# GOVERNMENT OF THE DISTRICT OF COLUMBIA DEPARTMENT OF GENERAL SERVICES

# SOLICITATION DCAM-21-CS-IFB-0001

# **REDEVELOPMENT ST. ELIZABETHS EAST CAMPUS PECAN STREET INFRASTRUCTURE IMPROVEMENTS**

# **AMENDMENT NO. 5**

Attachment J.1.13 – Elevated Steel Water Storage Tank Utilities

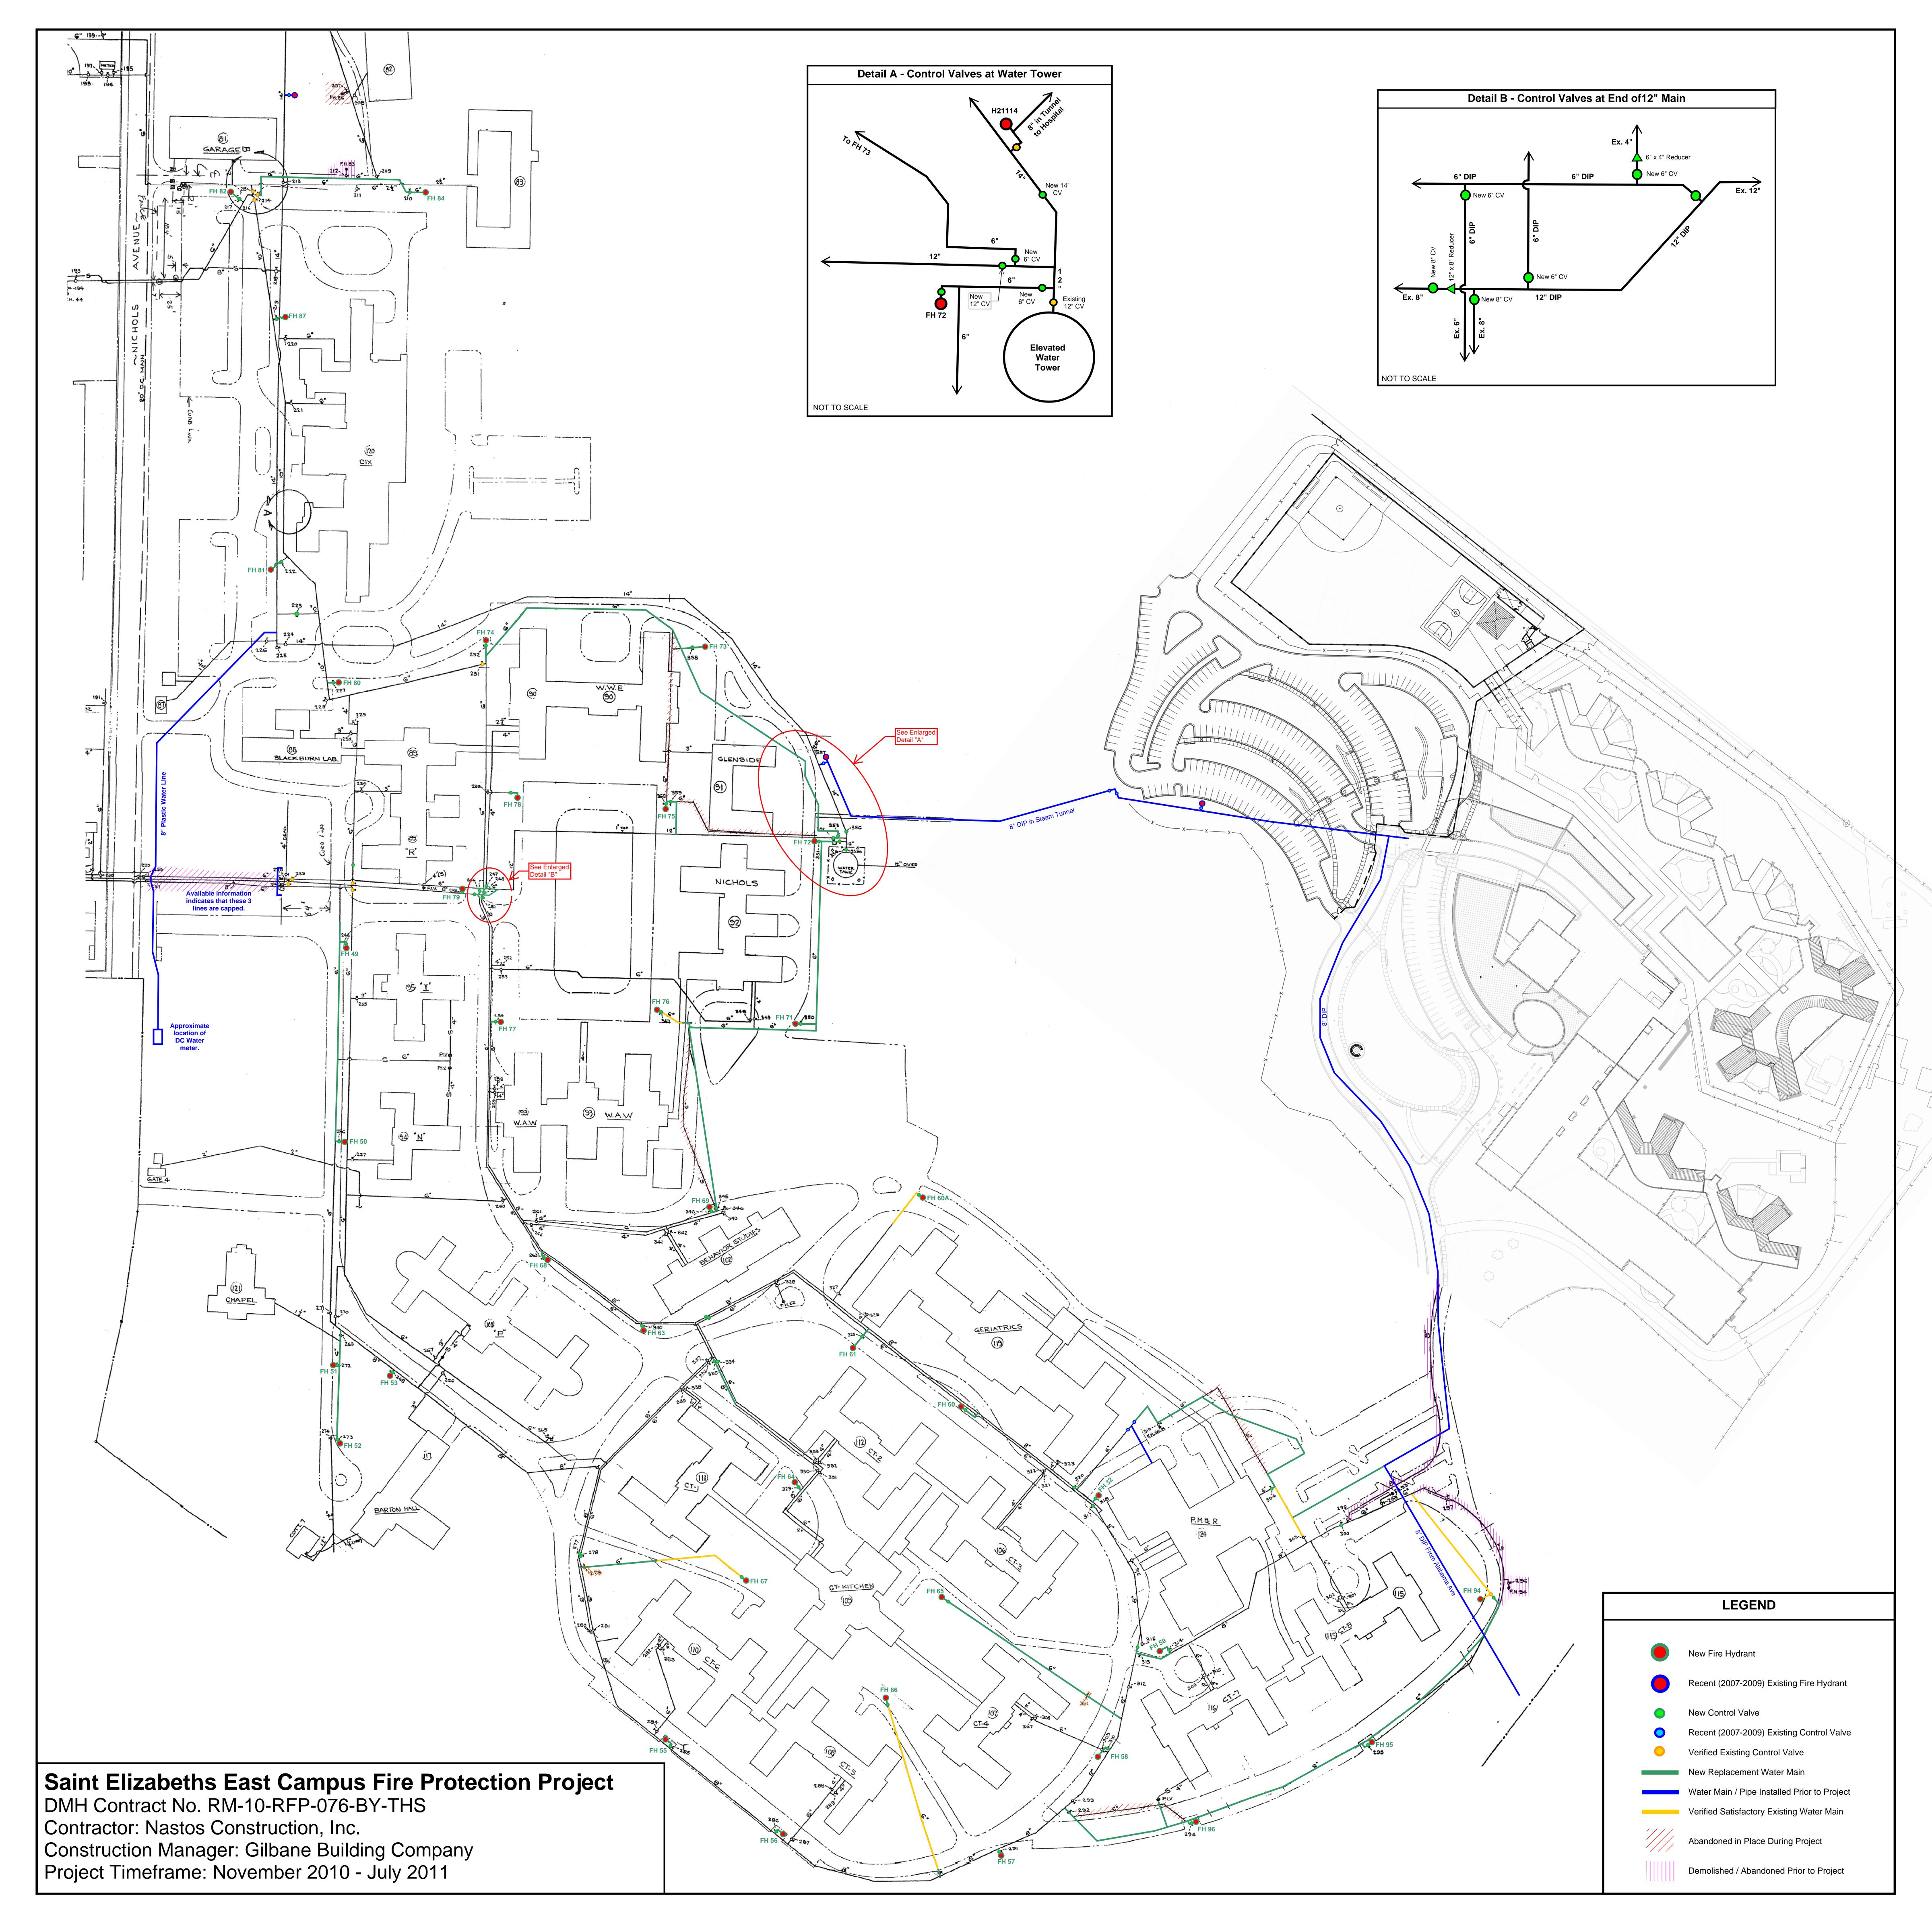
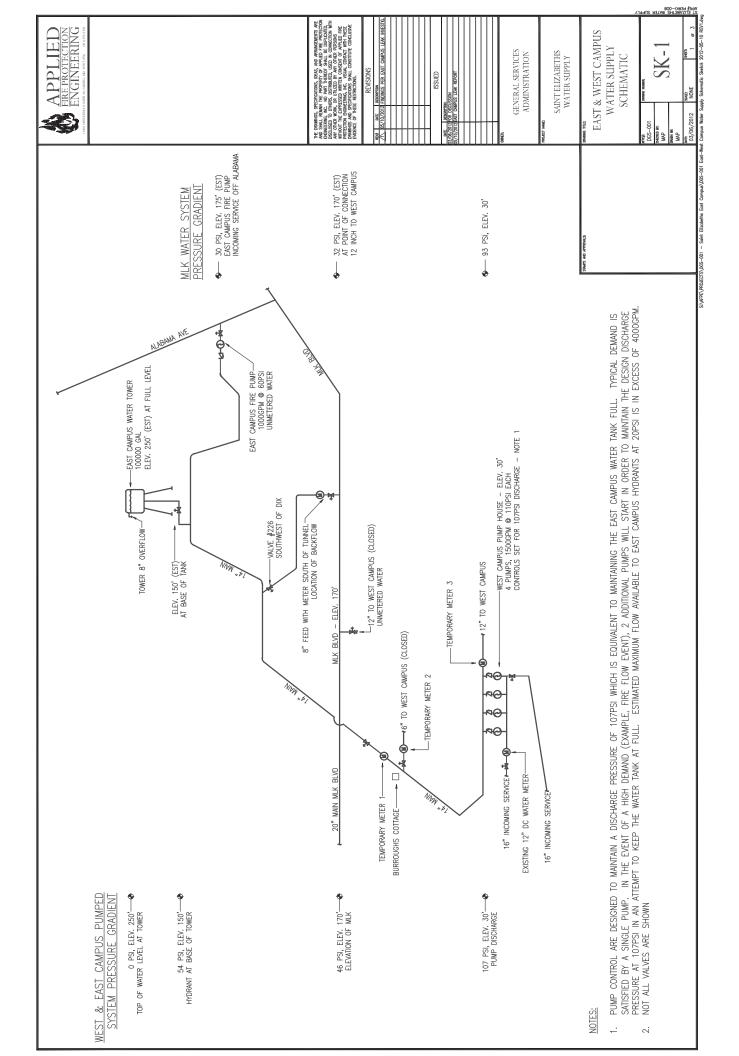
36	J.1.1	Item 205009 refers to the demolition of the existing steel elevated storage tank. Can we get additional information on this tank, such as as-built showing the connections to be abandoned?	Additional schematic plans have been included in amendment for information only. No guarantee to accuracy of the plans. None of the antennas are active per DMPED. See SP # 22 and J.1.13.
37		The cost of Line 0725, Item# 614999 – PEPCO charge for connection/inspection and line 0810, item # 614999 Payment to PEPCO for Connection, Disconnections, Inspection depends on Pepco's discretion. The District typically provides a lump sum cost for these items. Can you provide us the price of these items?	PEPCO indicated no charges for Pecan. These bid items would be for only the costs of the contractor to make any connections in the field. PEPCO charges are in the DGS allowance and not in these bid items. See SP # 12 and J.2
